AGENDA

PLANNING AND ZONING December 10, 2015 @ 7:00 P.M.

Re: Kings Crossing – Phase 3

As requested, we have reviewed the Preliminary Plat and Engineering Plans for the Kings Crossing Phase 3, dated October 28, 2015. We received these plans from Westwood Professional Services on November 3, 2015.

**PRELIMINARY PLAT
OF
KINGS CROSSING PHASE 3
38 LOTS/49.169 ACRES
OUT OF THE
ANN S. HURT SURVEY, ABSTRACT NO. 428
IN THE
CITY OF PARKER, COLLIN COUNTY, TX**

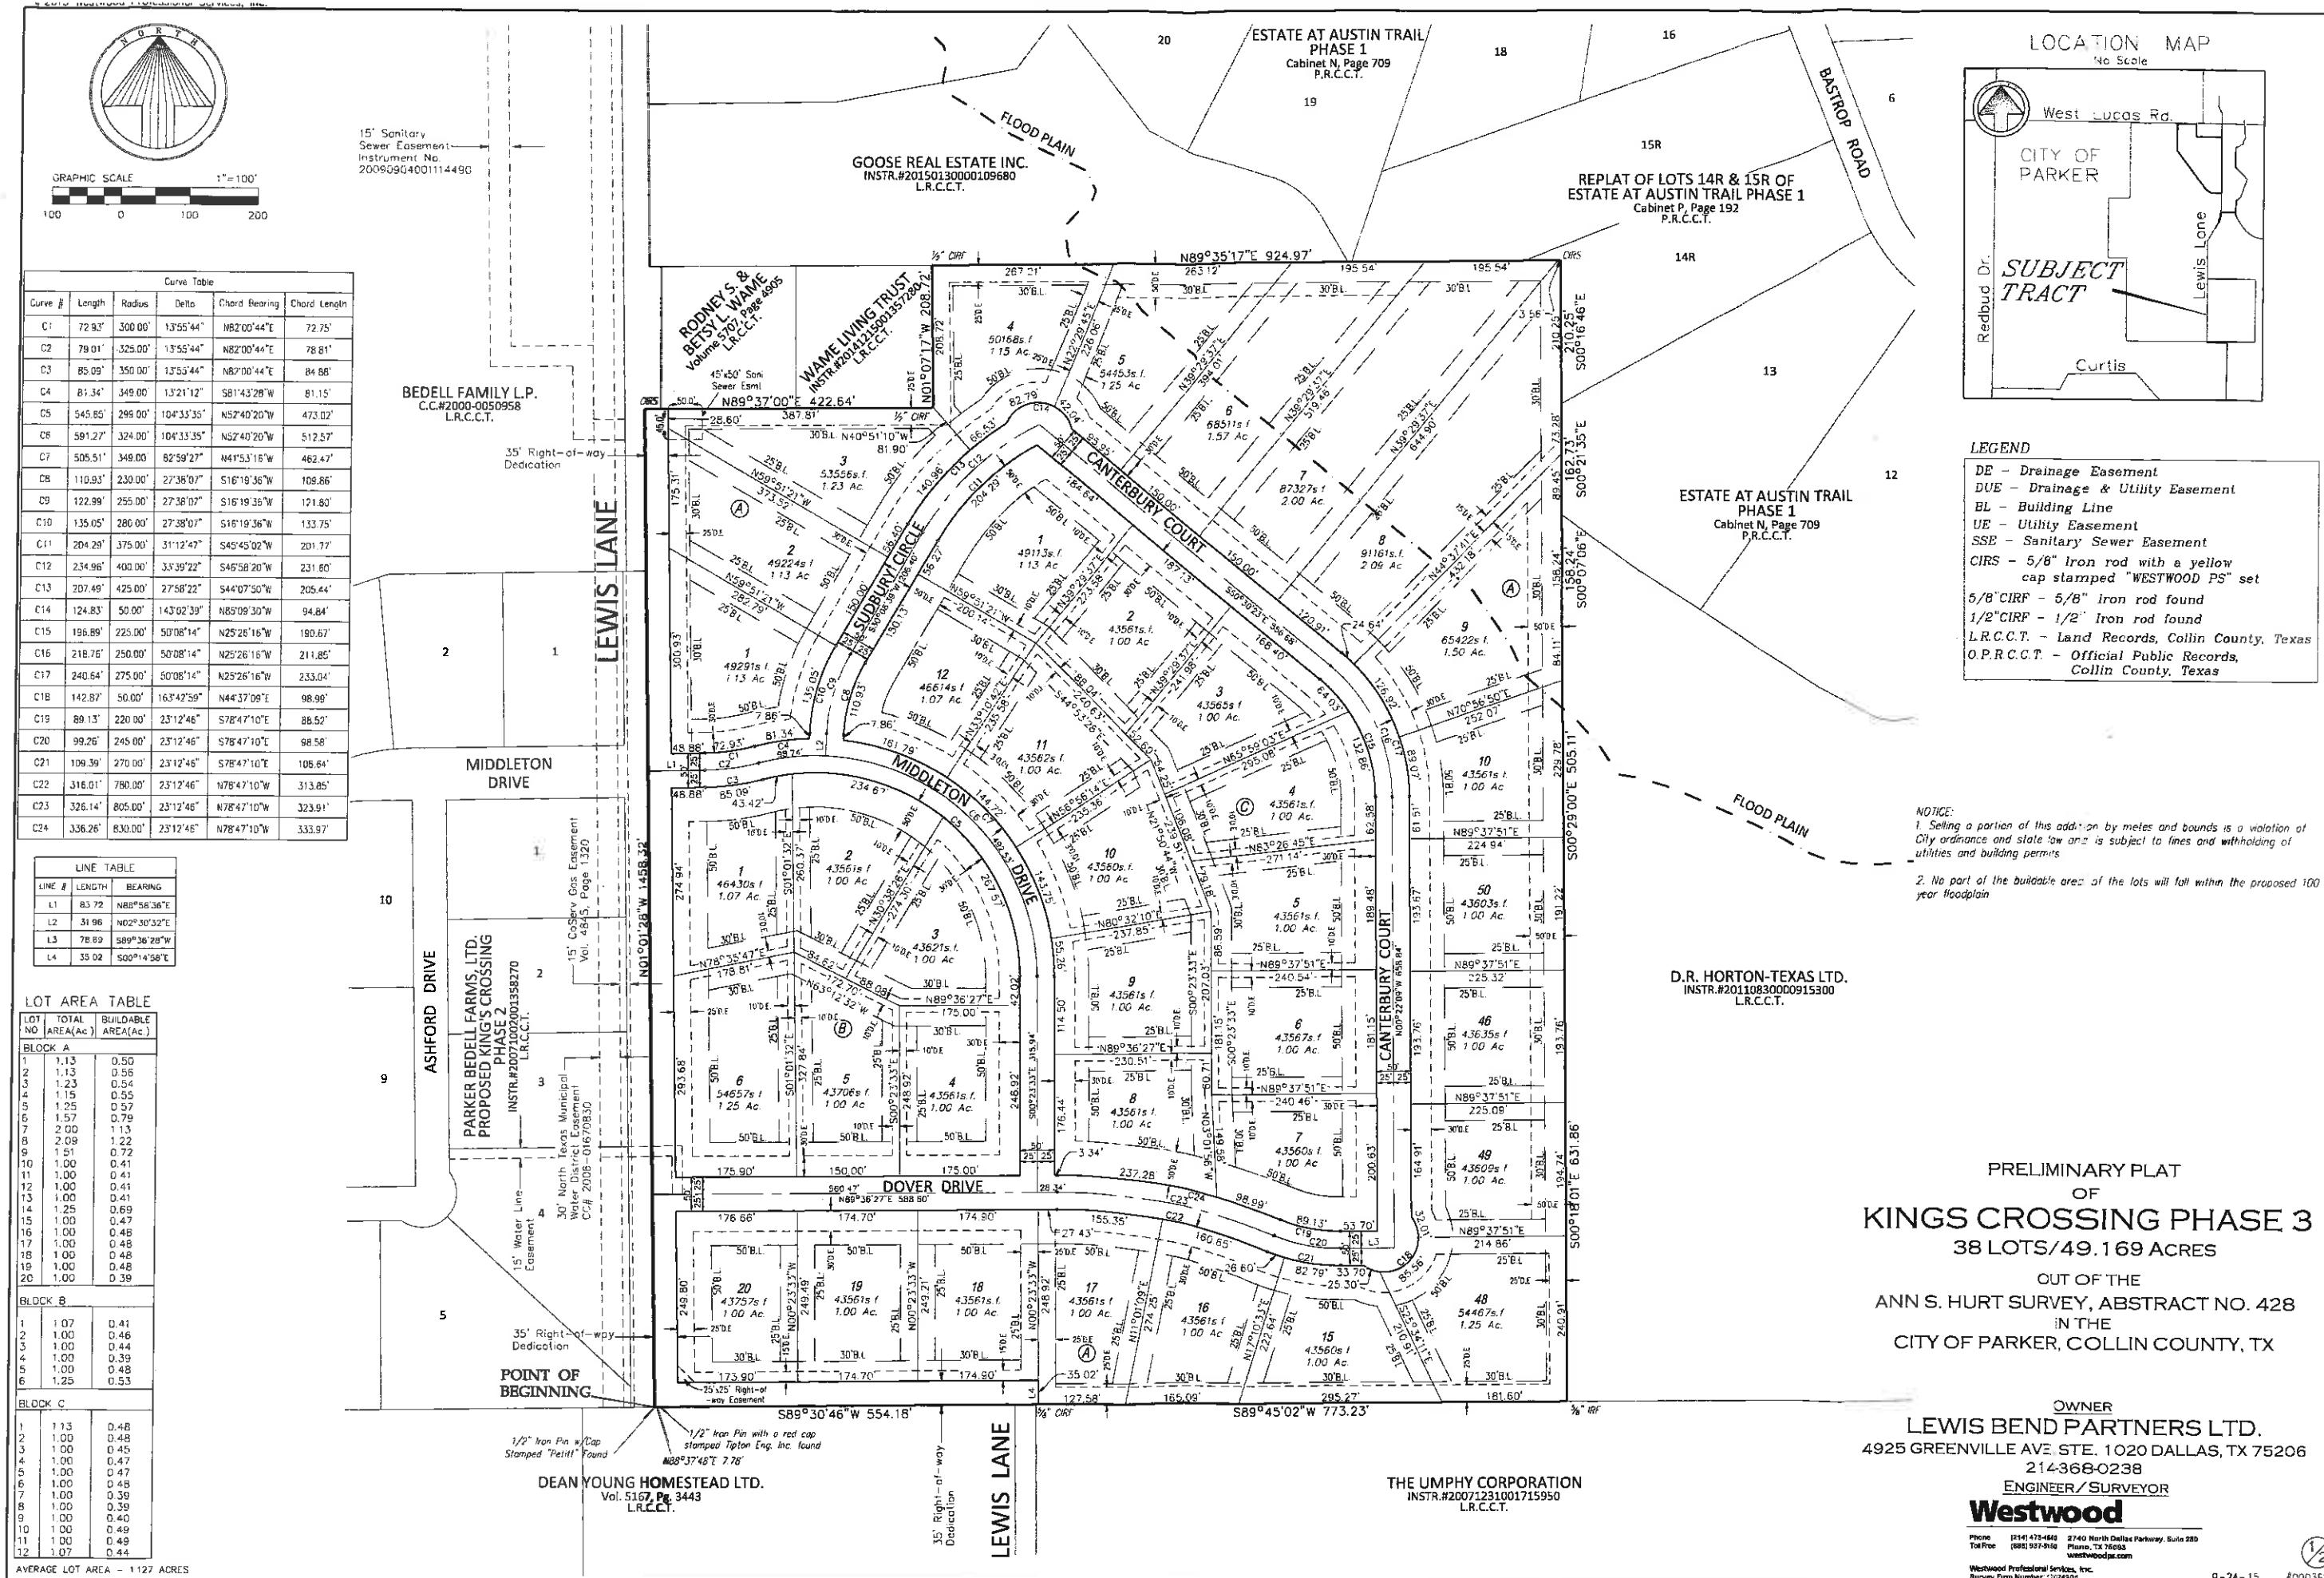
1. Water line easement required where water line is shown outside Lewis Lane ROW.
2. The drainage easements shown on the plat are not adequate for the depth designed for in the cross-sections.

3. Verify the grading of the lots, channels and roads with regards to the channels. It appears that the 100-year WSEL is not contained within the channels but not enough cross-sections are provided to show this. As an example, station 20+00 of Ditch 3 has a flow line around 590.00, an eastern top of bank of 593, no top of bank between the flowline and the building pad to the west, the building pad at an elevation of 595.20 and the 100-year WSEL at 596.65. **(100-year WSEL above the building pad)**
4. Existing contours are unclear at the southeast corner. Proposed contours do not tie into existing in several locations.
5. Manning's roughness coefficient used of 0.030 signifies a well maintained channel. While this may be the intent of the channels along the individual lots (please confirm), is there a maintenance agreement that will regularly maintain the channel along Lewis Lane as well.

6. Provide the previously submitted drainage report that included this phase. The previous phase that was submitted with the report included calculations regarding valley storage. It is unclear if those calculations included the proposed grading with this phase. The proposed plans show fill in several areas of the floodplain but does not address any valley storage loss. It appears that a pond is being filled in with this grading as well, clarify if this was also part of the previous drainage study.
7. Label the velocities in the creek being discharged into.
8. 2 fps is minimum velocity in the drainage channels.

9. Detail the connection to the existing lift station. It is unclear if a connection is being made to a manhole or the wet well. Will by-pass pumping be required?
10. 2-foot vertical separation is required between all utilities. SS Line E shows a storm RCP directly on top of the sanitary sewer line.

11. Provide a geotechnical report.
